Groundwater & Wastewater Services
Septic Project File & Data Review Worksheet

Permit #: **30003028** GWS File #: **5693B** Tax Parcel #: **199-601-20**

Reference: **Request for a revision to the Septic Improvement Permit for Lot 37 at The Sanctuary at Lake Wylie Phase**
Mecklenburg County Health Department (MCHD) File # 5693B

Design Specifications for Lot 37 at The Sanctuary
MCHD File # 5693B

ORIGINAL 6-2-05 To ast
Revise

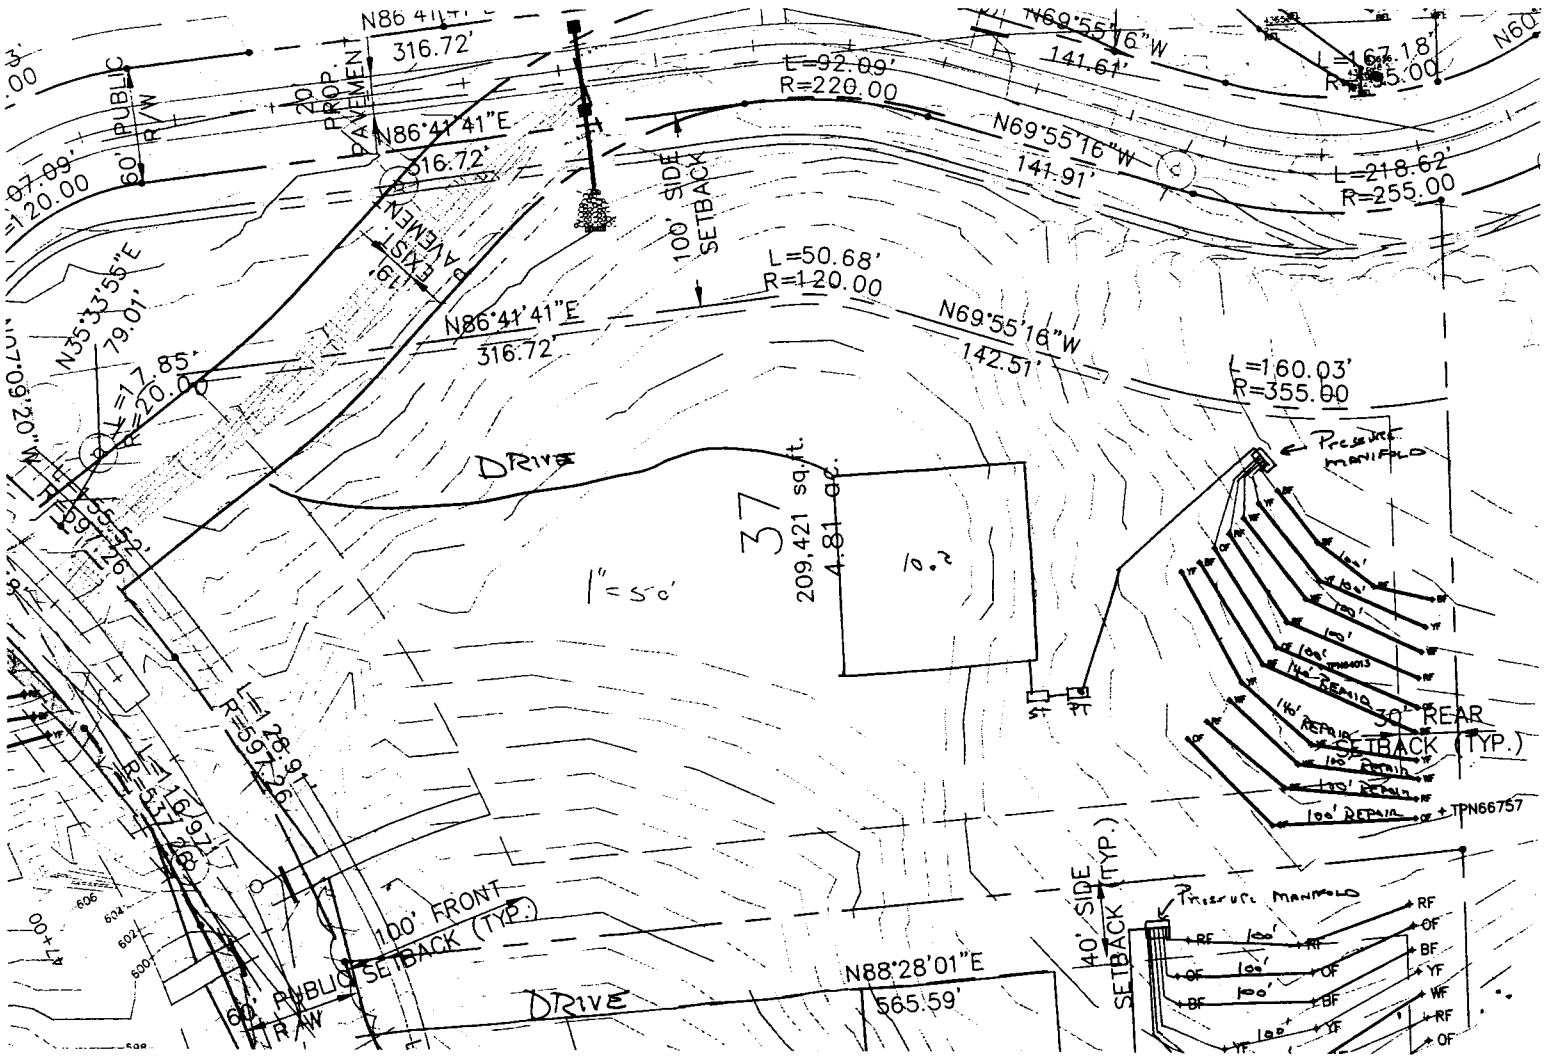
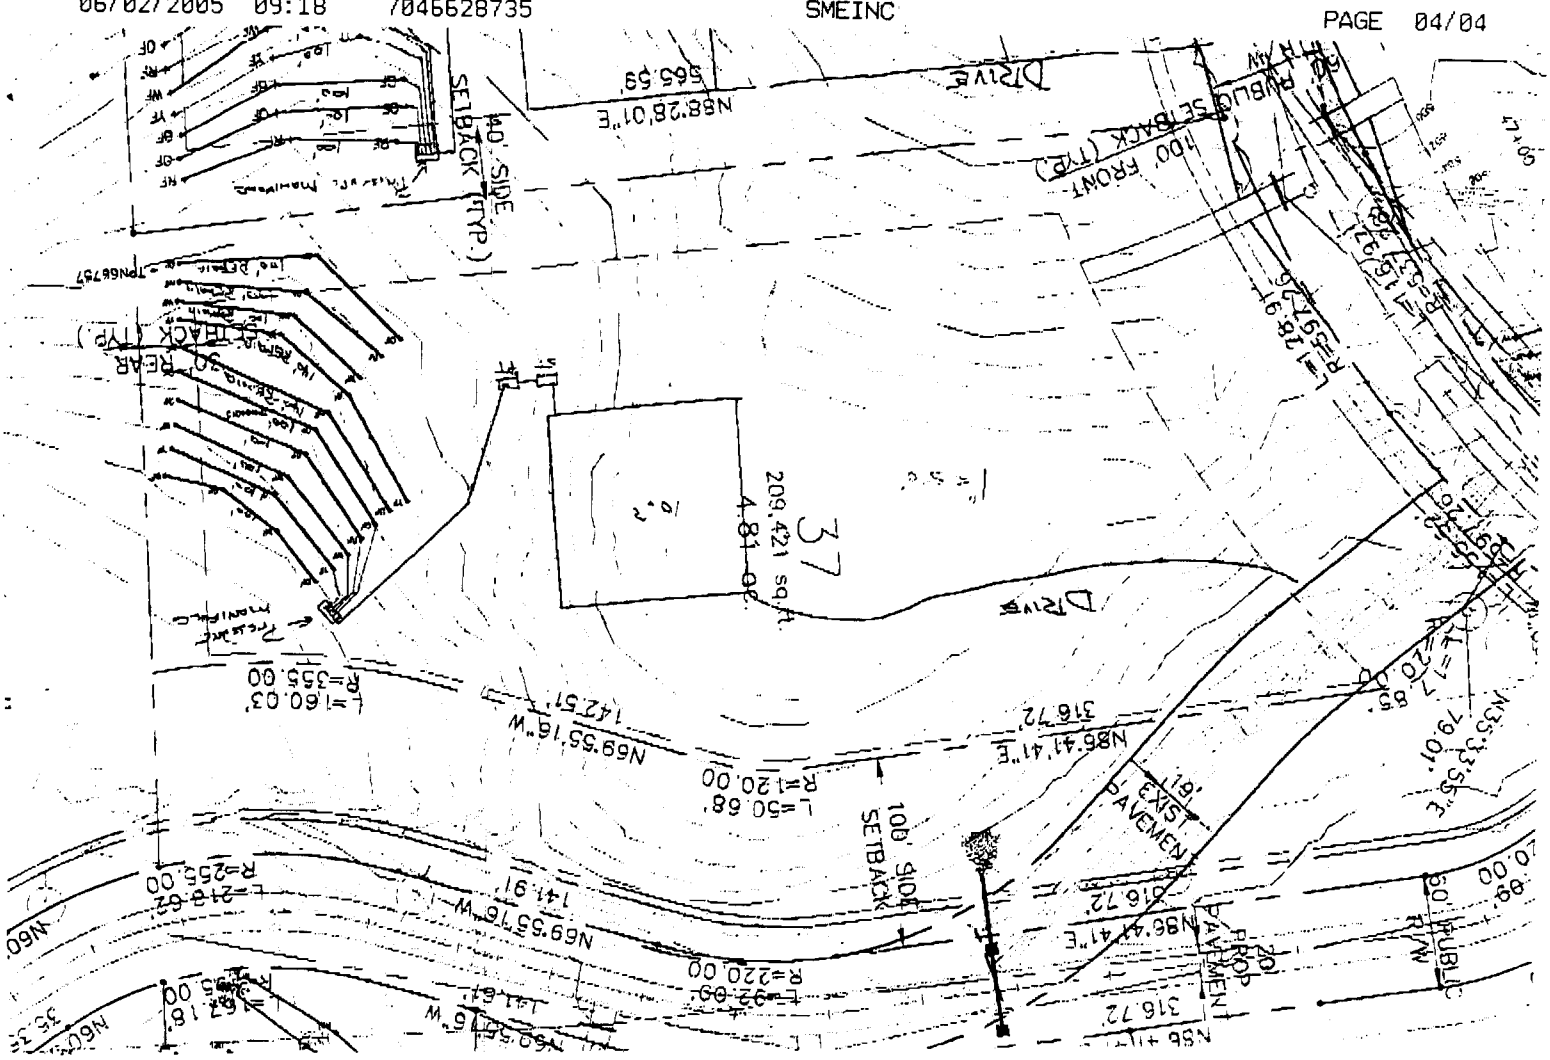
The Sanctuary at Lake Wylie is requesting a revision to the septic Improvement Permit for the above referenced lot. The lot was originally permitted for a 5 bedroom home on June 2, 2005. The only change made to the lot was that the abandoned roadway was removed from lot 37 and added to the COS. The septic system drain field and house locations are the same on the new site plan as they were on the June 2, 2005 permitted site plan.

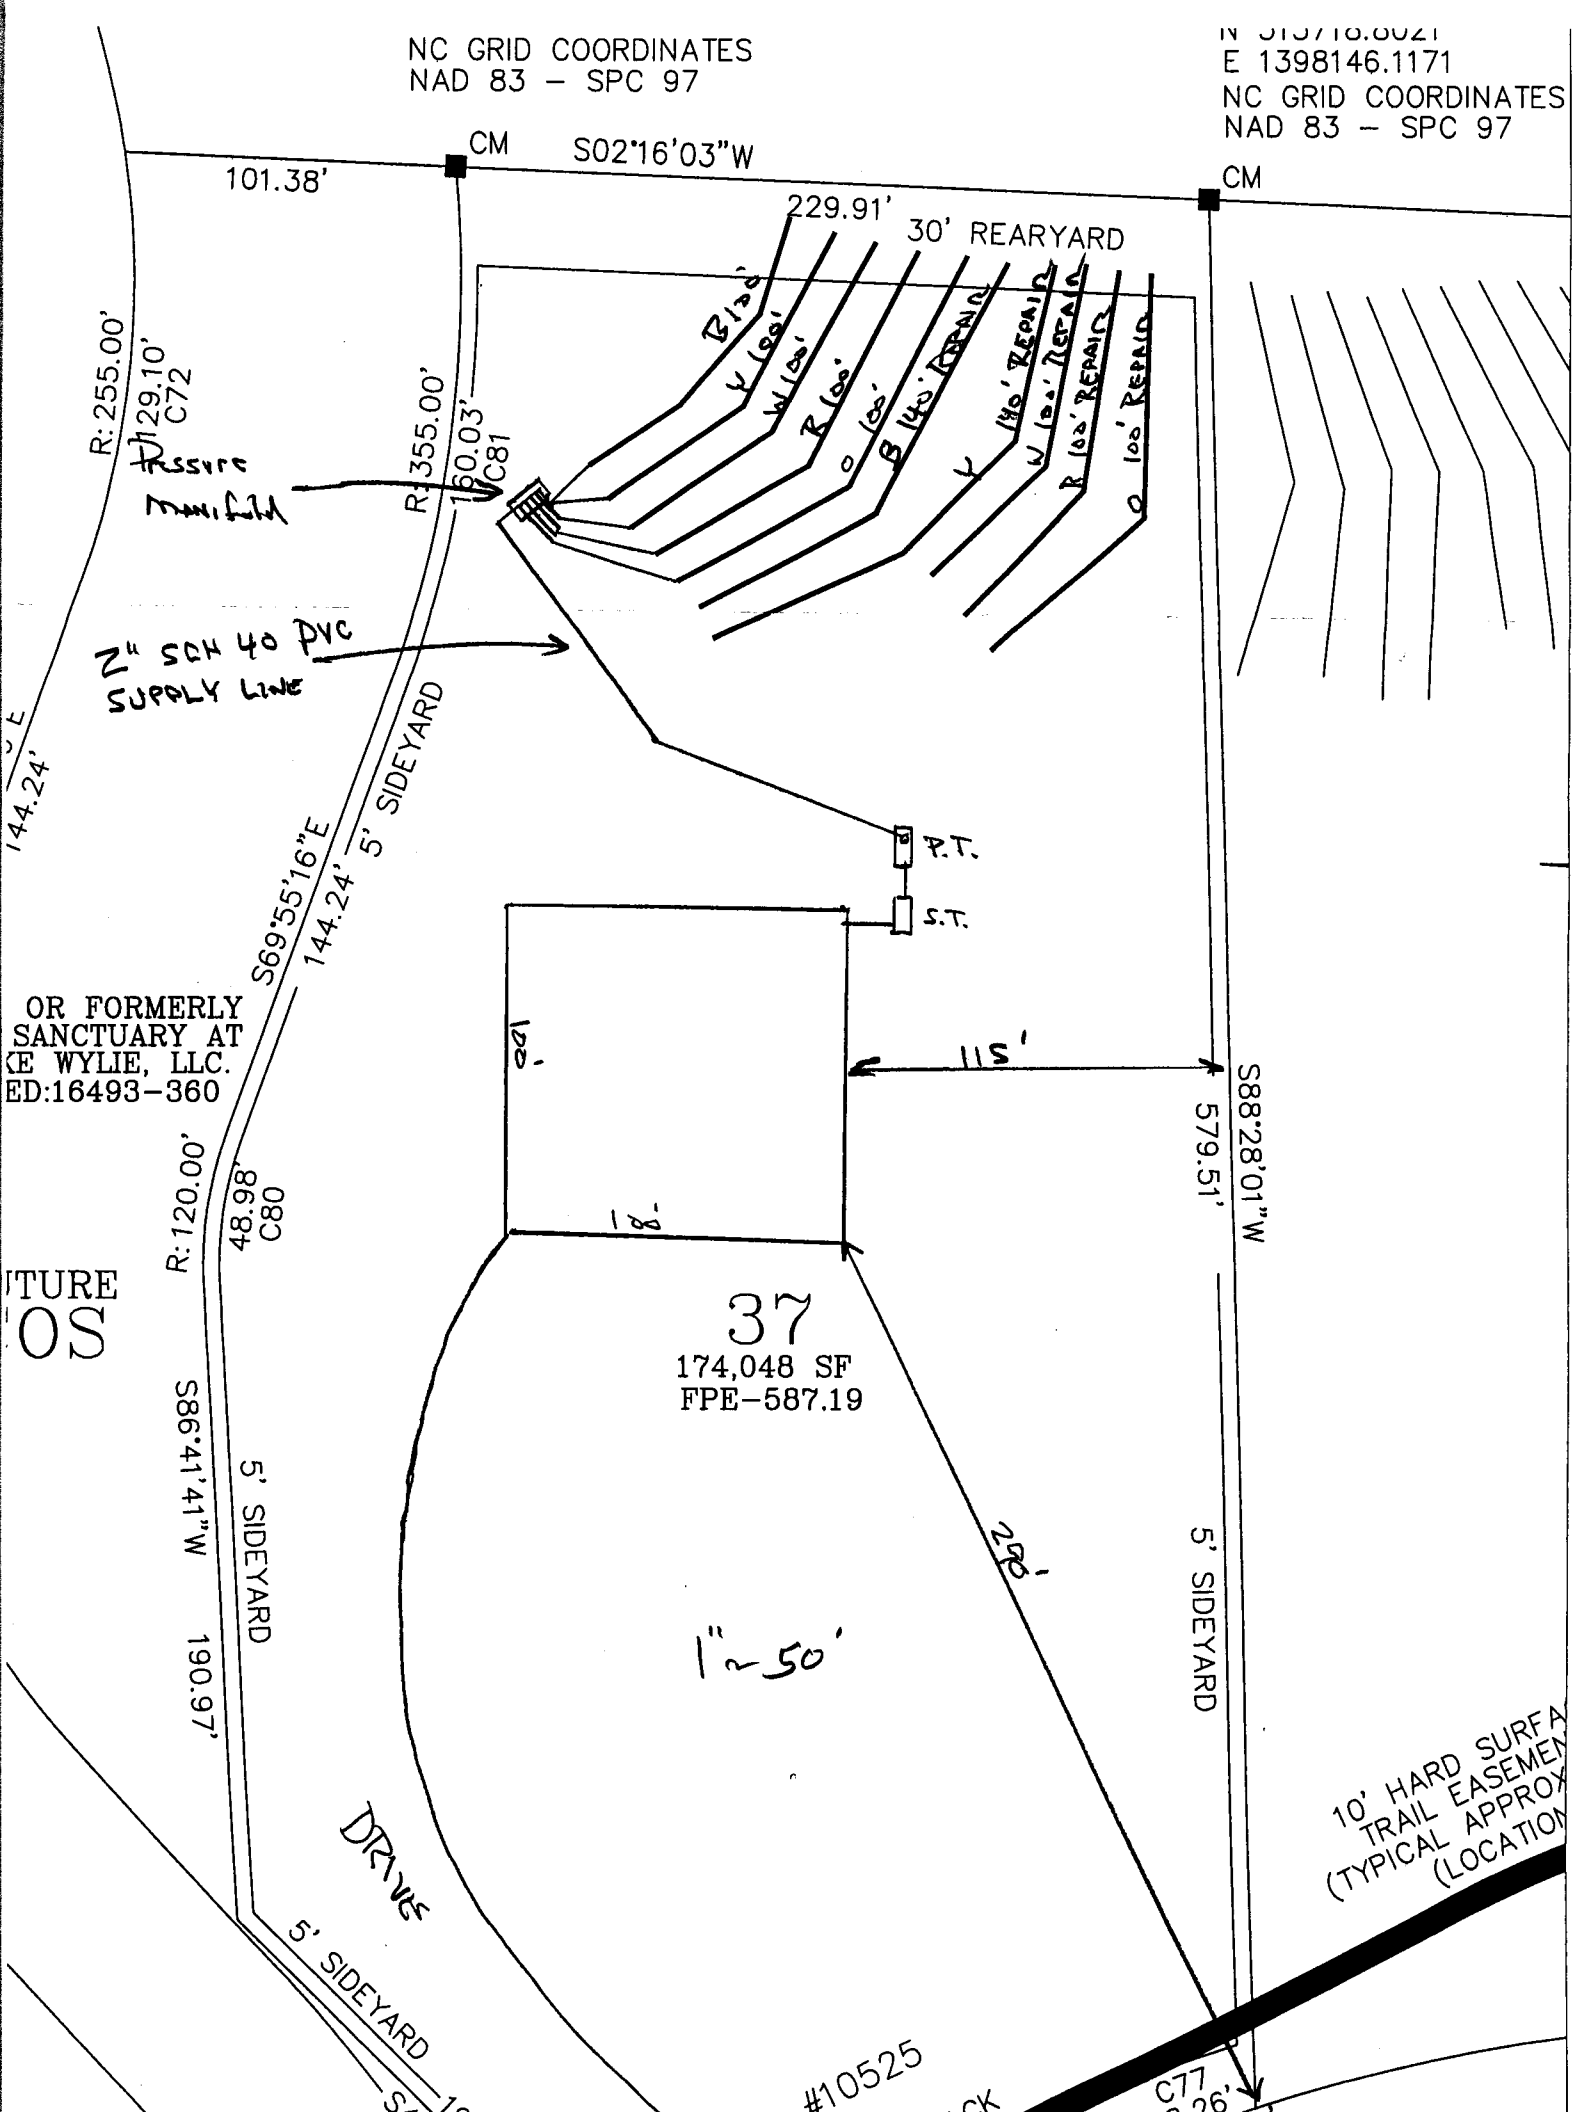
Mr. Bill Marlin has evaluated the soils (see attached MCHD soil sheets) and S&ME, Inc. has flagged the system and repair on the lot. The septic lines have been located by your surveyor and are shown on the attached maps provided by YW&H, Inc. The attached sketch and specifications are not an Improvement Permit and are intended only to assist the MCHD in permitting the referenced lot at The Sanctuary.
